ADDENDUM NO. 3

Date of Addendum: 2-10-2025

PROJECT NAME: Lake Houston Wilderness Park Cottages

PROJECT NO: WBS No F-HAR014-0001-4-01-01 ; F-HAR014-0001-4-01-02

A1-01
 SCALE: As indicated

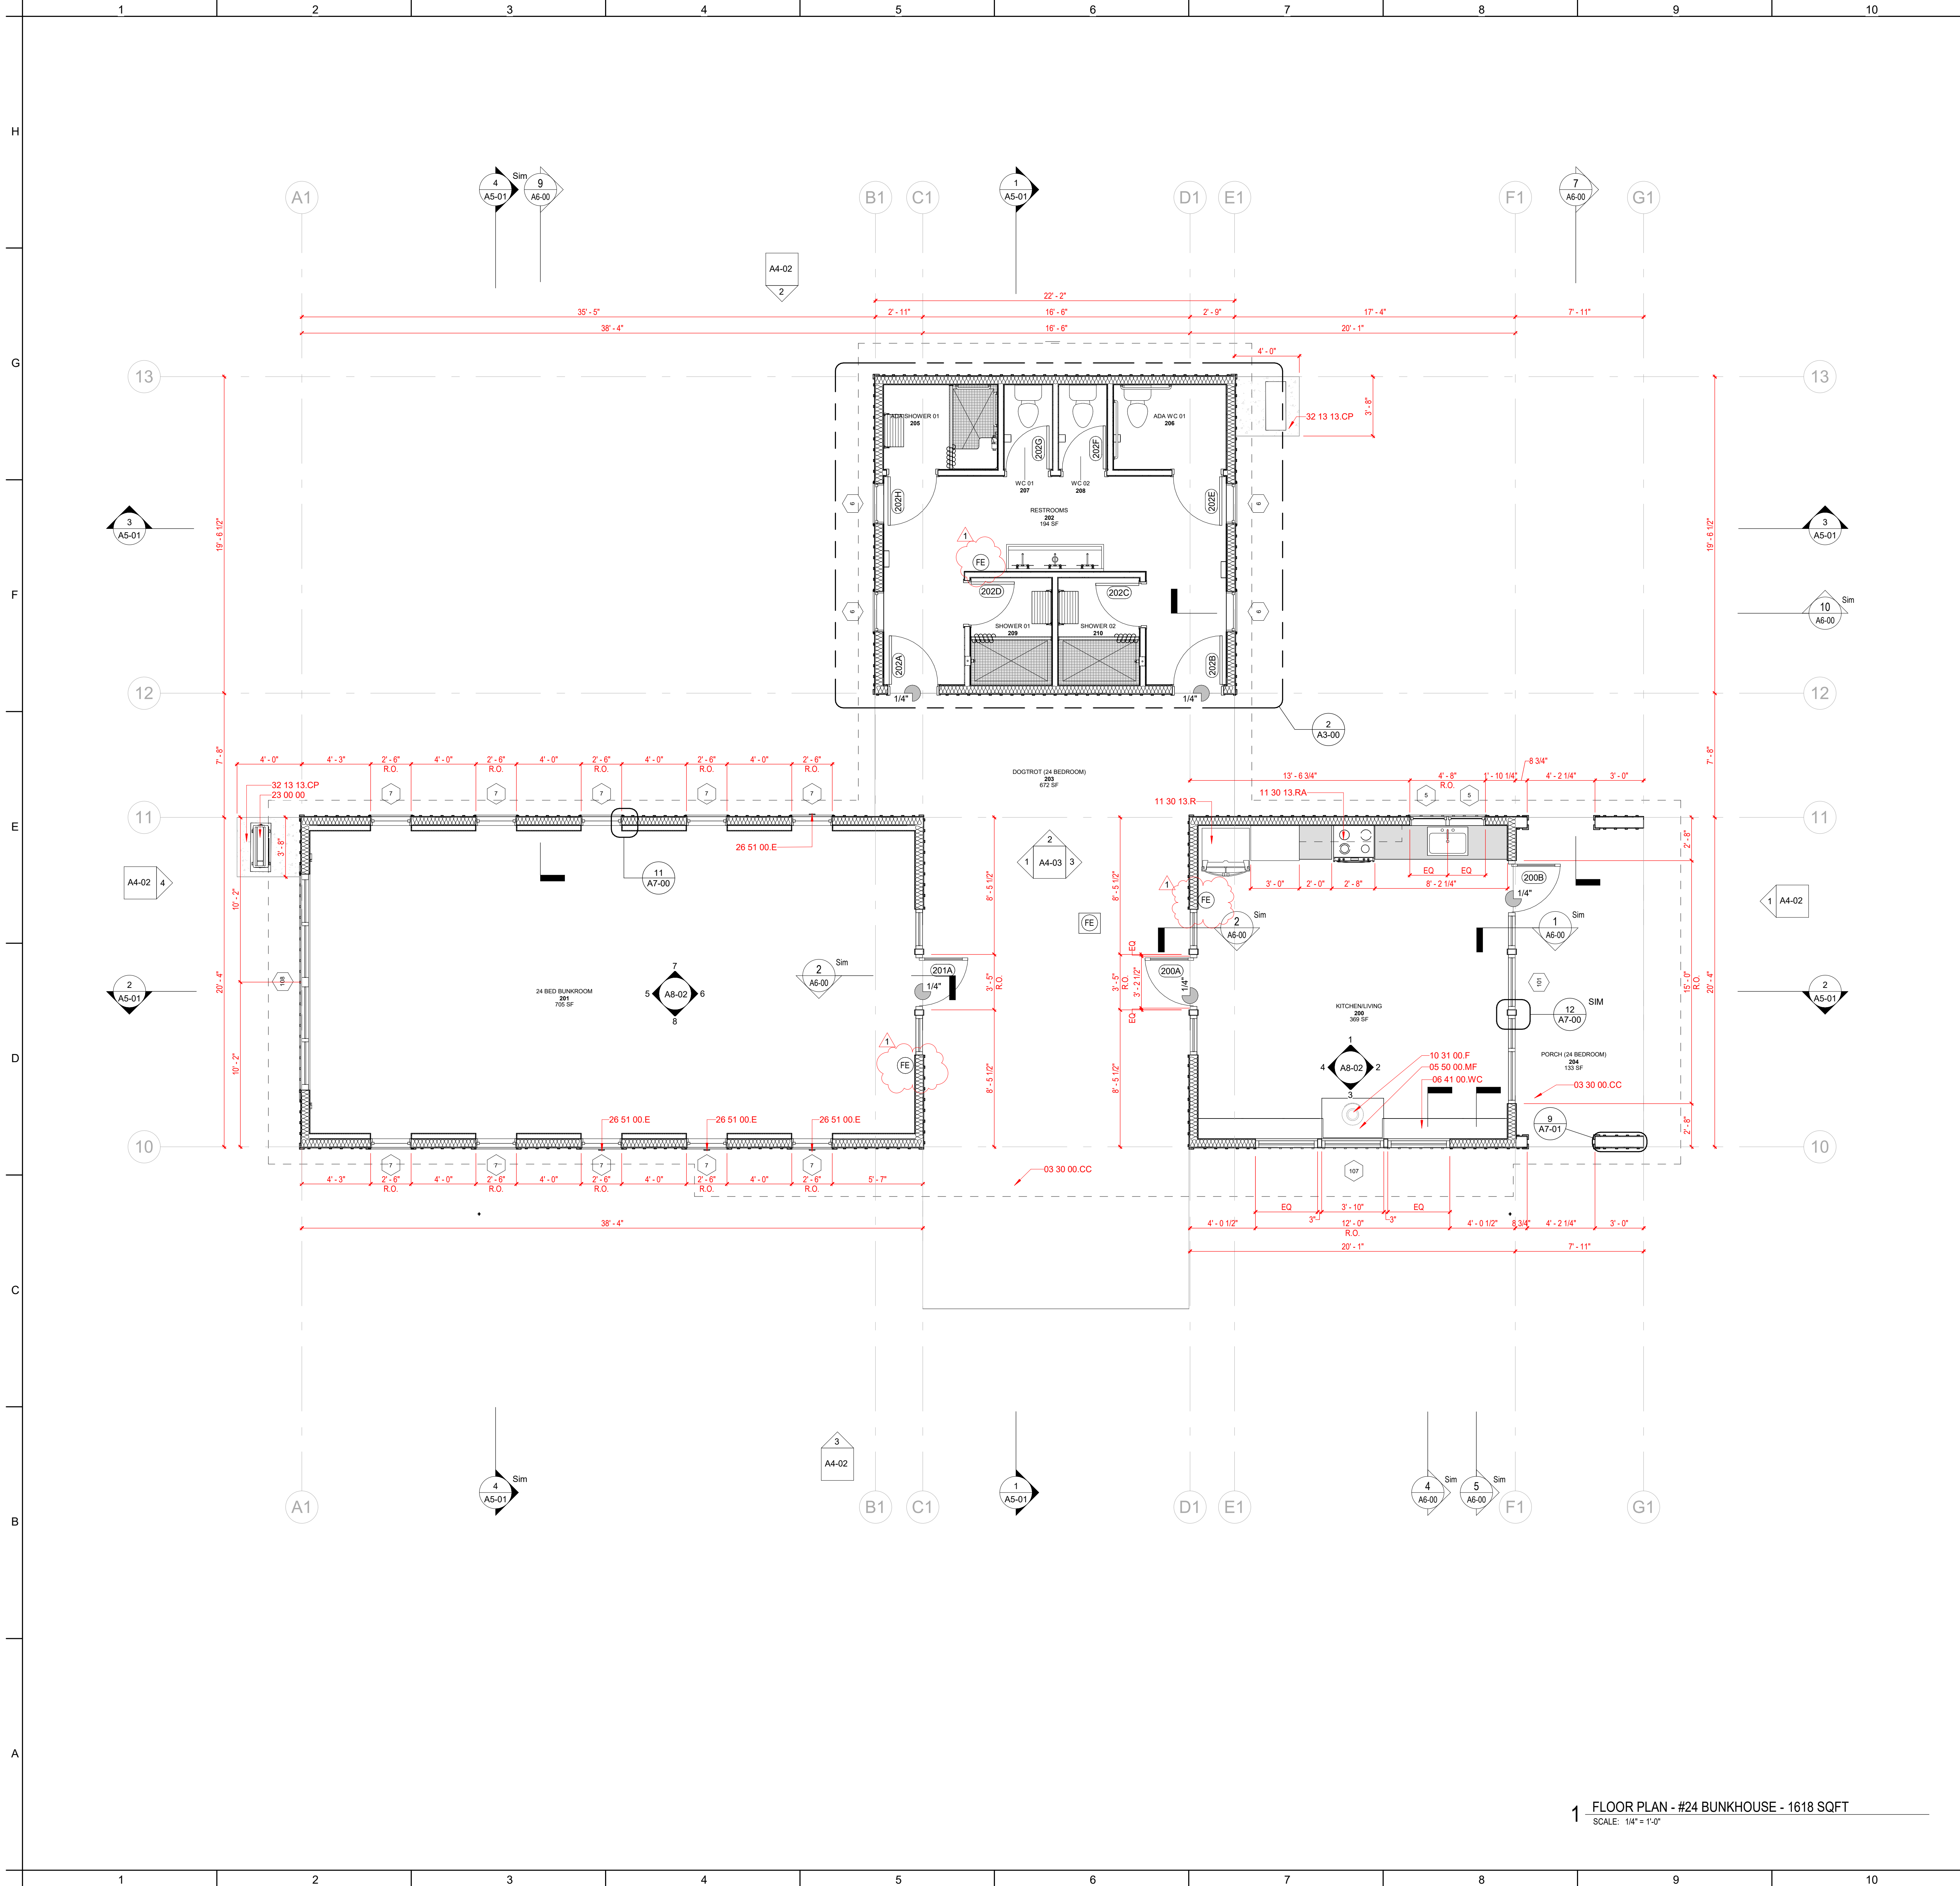
5. A1-01- FLOOR PLAN - #24 BUNKHOUSE, Add and replace with new sheet which: Added Fire Extinguisher locations per Permit Review comments
6. A1-02- FLOOR PLAN - #12 BUNKHOUSE, Add and replace with new sheet which: Added Fire Extinguisher locations per Permit Review comments

A2-02
 SCALE: As indicated

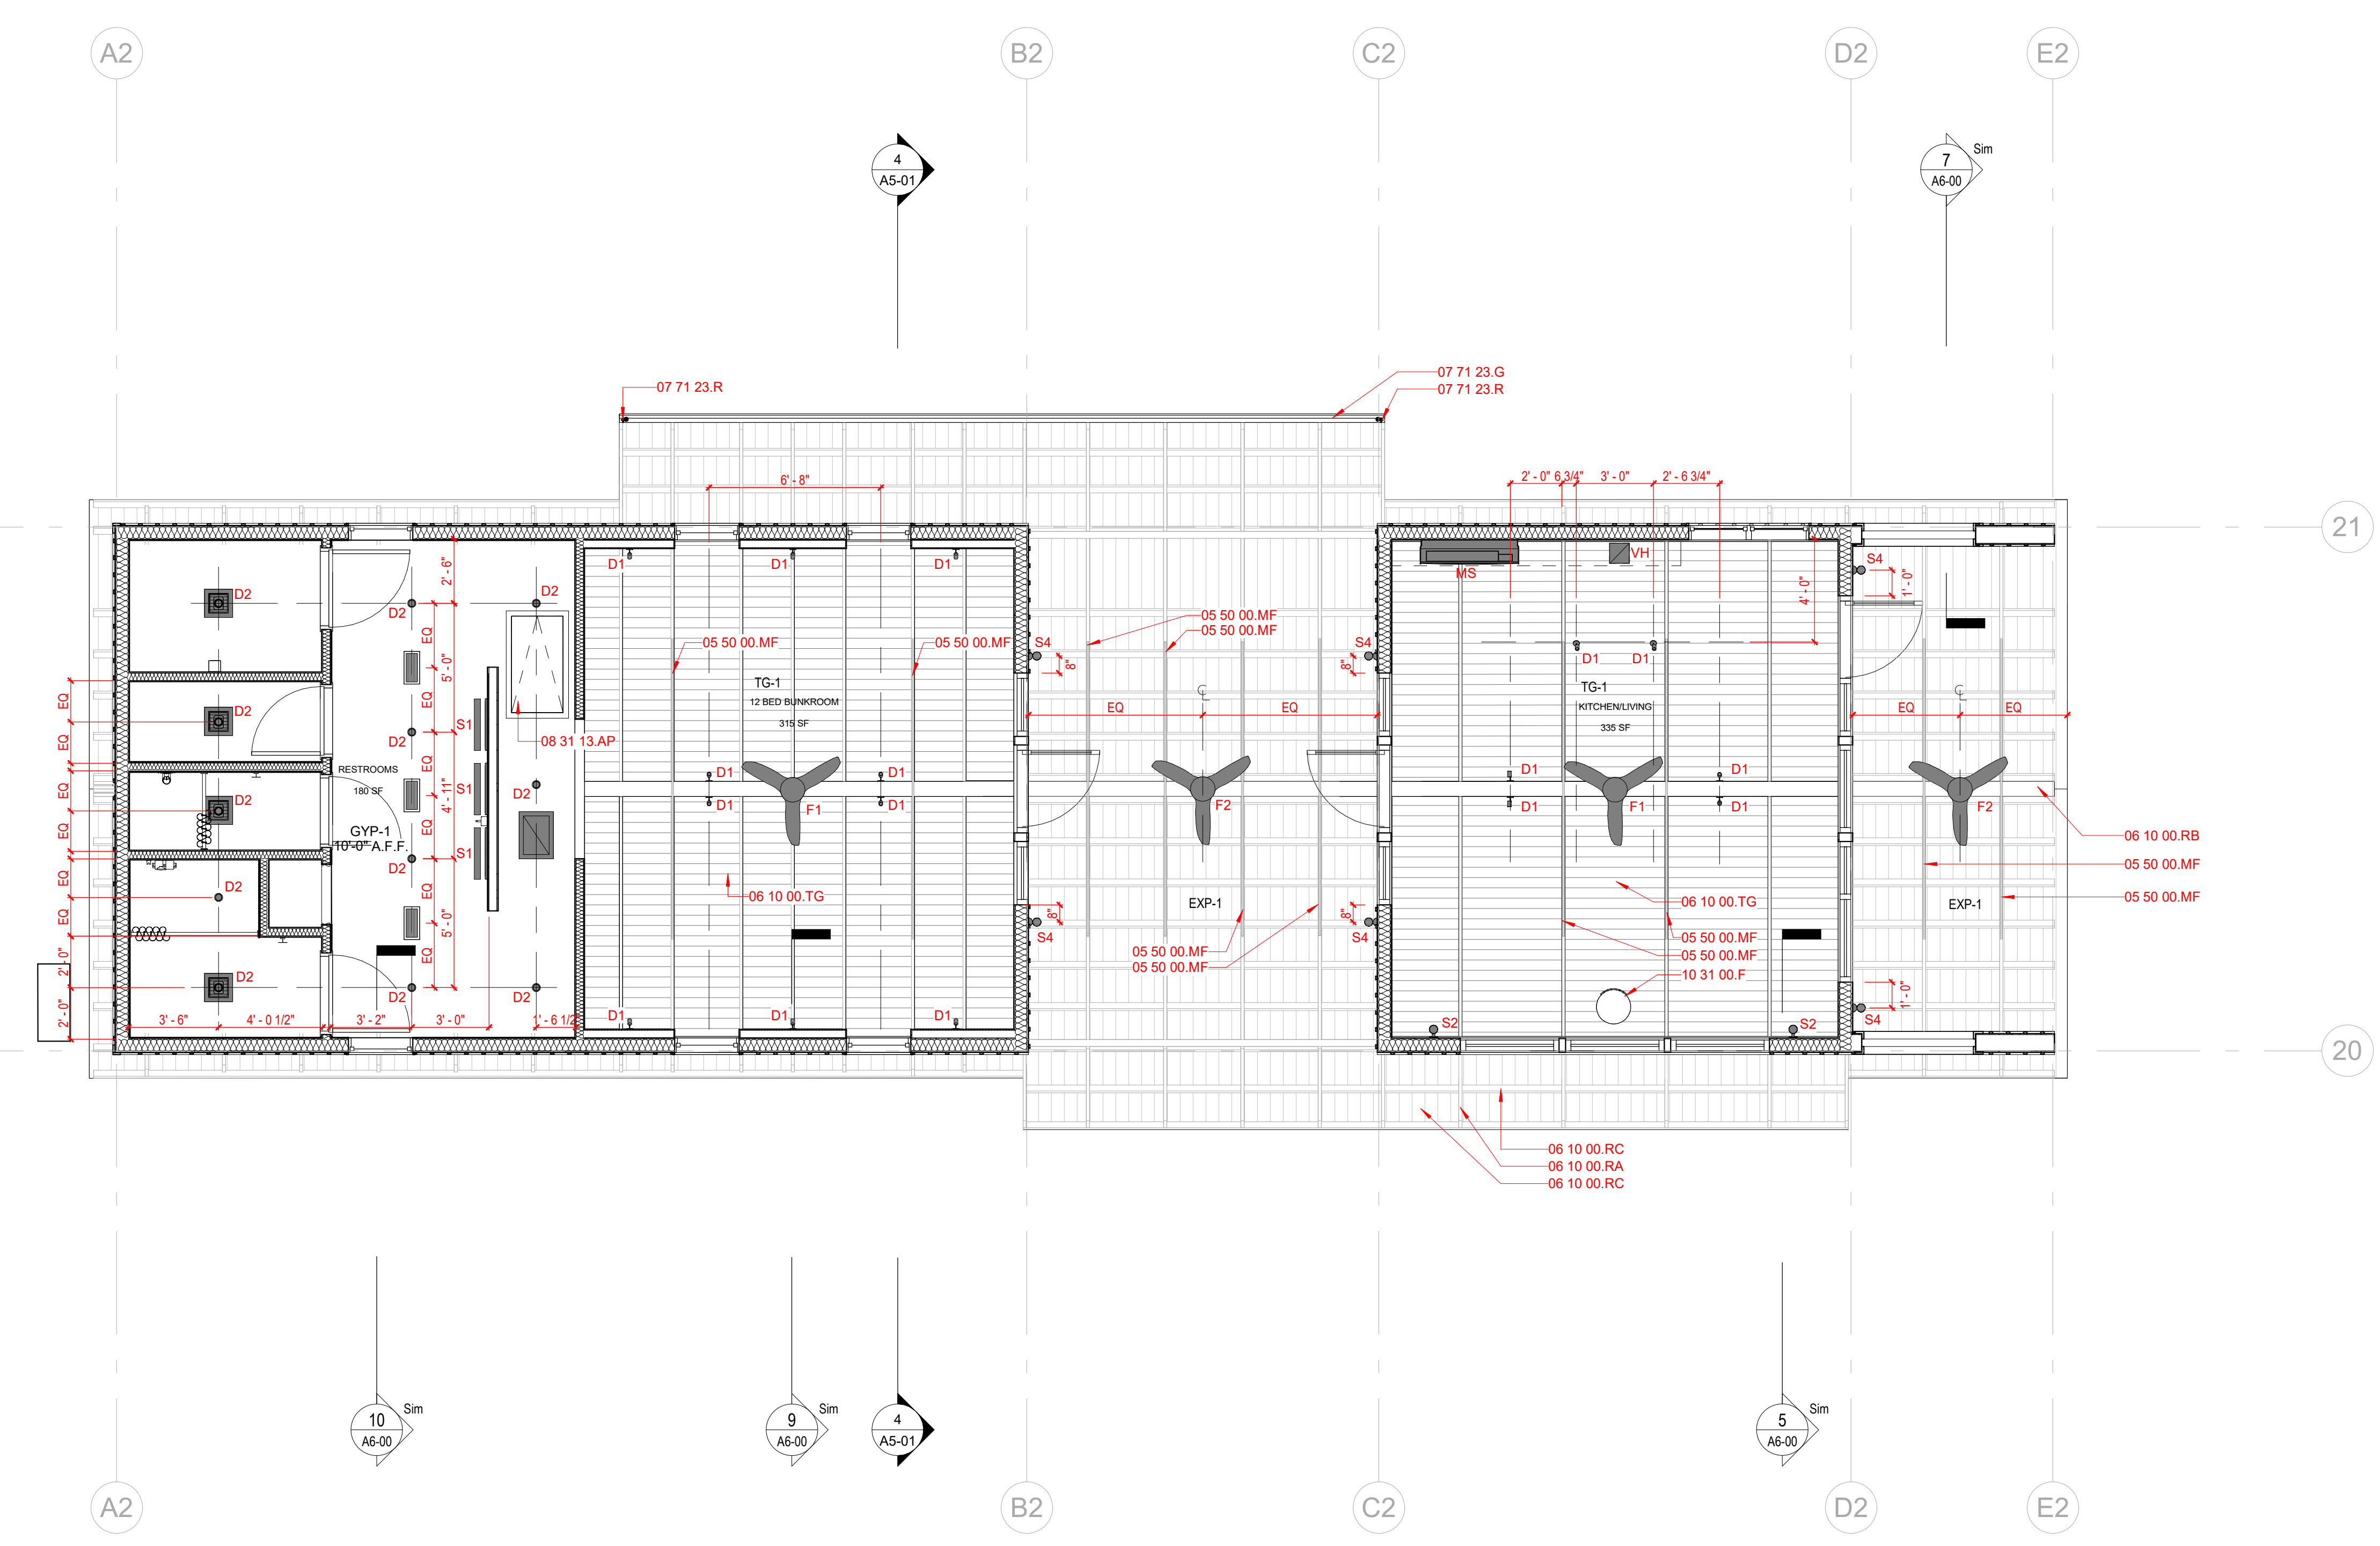
8. A2-02- RCP - #12 BUNKHOUSE, Add and replace with new Sheet which: Revised General Notes to clarify Fire Sprinkler System requirements per Permit Review comments and bidder questions

C. Fire Sprinkler System is required. Contractor shall engage a registered firm to design and submit Fire Sprinkler plans directly to the Montgomery County Fire Marshal's Office for review and approval prior to installation. Sprinkler System shall include a **Water Flow Alarm**; see **Fire Alarm Sheets**. Sprinkler System shall be designed and installed in accordance with the Specifications in Division 21 and comply with the following codes and standards:
 - IFC Sec. 903
 - Montgomery County Exhibit A
 - NFPA 13R
